**FIELD SERVICE BULLETIN**

FSB Number: LVCCFSB2005-13  
Author: Tony Bryan  
Date: February 8, 2005  
Total No. of Pages: 3  
Subject: GSM V500 (Rev J1 PCB) –Incorrectly Phased in HZ Factory  
Phone Models: GSM V500 SUG3052HA and SUG3054HA  
Level of Repair: 3

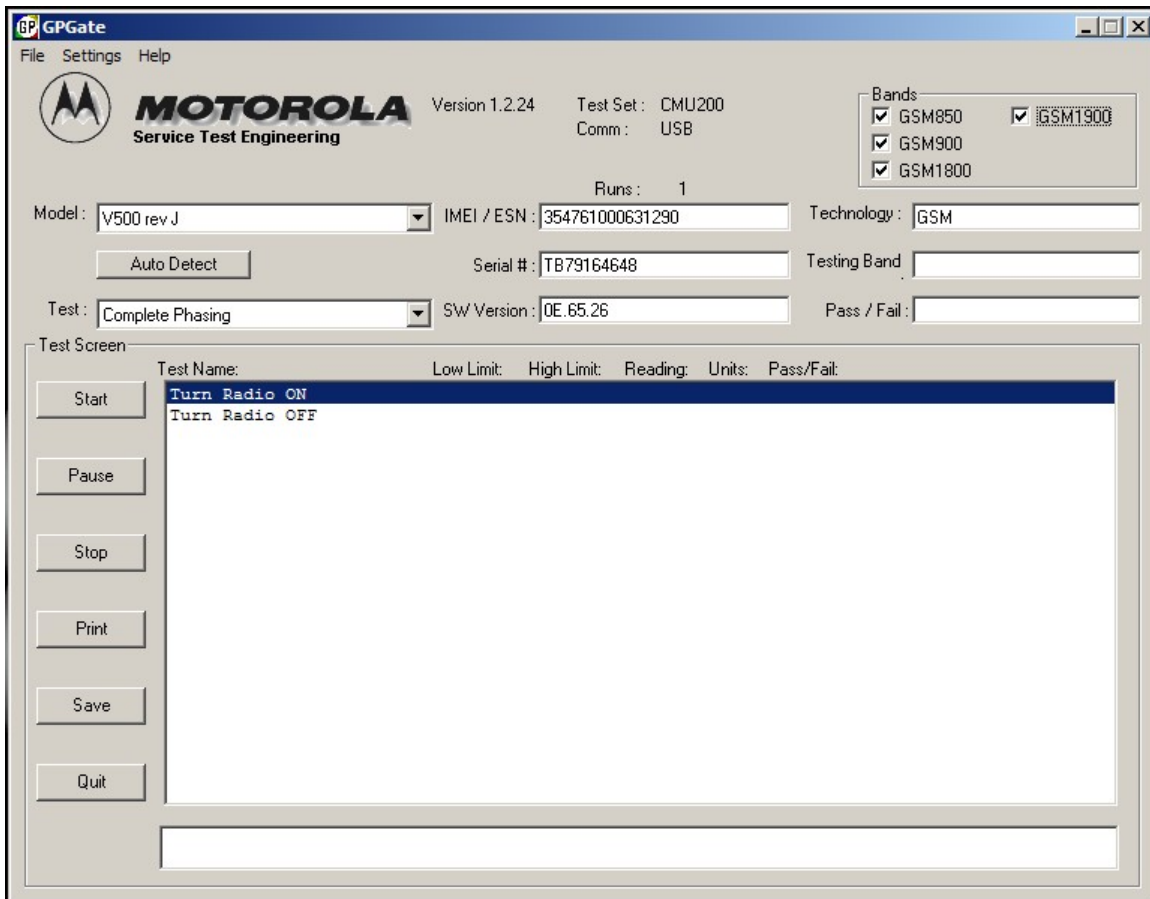
When servicing affected models of GSM V500 customer returns, that were manufactured in HangZhou China with letter G on the serial number and date code from RT\* (Week 44 Thursday) through Tm\* (Week 46 Monday), regardless of customer complaint, then:

1. Follow normal testing and troubleshooting techniques to identify and repair the unit per the customer complaint.
2. Completely rephase the unit on all active bands (i.e. Quad Band) using GSM GP-Gate\_1.2.24 or later version.
3. Auto-Detect Phone Model and select "V500 rev J". Then select "Complete Phasing" from the Test drop down menu. (See Image Below)
4. After rephase is completed, unit should be run through "Call Processing" testing in GSM GP-Gate to verify RMS Phase Error is within spec. across all active bands.

5. Unit should then be marked with a green dot on the upper left corner of the factory label pictured above.
6. Follow normal testing and troubleshooting techniques to repair the unit per the customer complaint.
